16_09 Data Field Limitations on Profile Hydraulic Data Cells

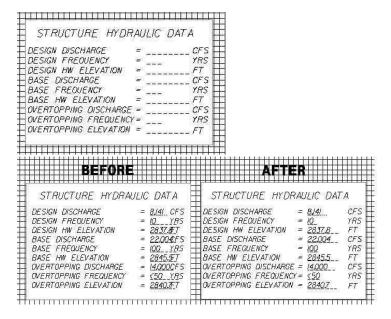
Could the cell for Structure Hydraulic Data be modified to accommodate more characters in the data fields? This happens to be a mountain project and I need more spaces so as to put the elevations, etc. in. Now, with four or more characters, it overlaps the unit.

- 1. The data fields overlap the unit labels.
- 2. Current data fields are limited to 7 characters per line.

1. Without changing the original size of the Hydraulic Data cells, data fields are shifted so that they do not overlap the unit labels. 2. Base number of characters per data field line have been adjusted accordingly.

- Discharge rates and elevations data fields increased from 7 to 8 characters.
- Frequency periods data fields are reduced from 7 to 3 characters.

In addition, along with the Structure Hydraulic Data cell, the Bridge Hydraulic Data, the Culvert Hydraulic Data, and the Pipe Hydraulic Data cells have been modified in the same manner.
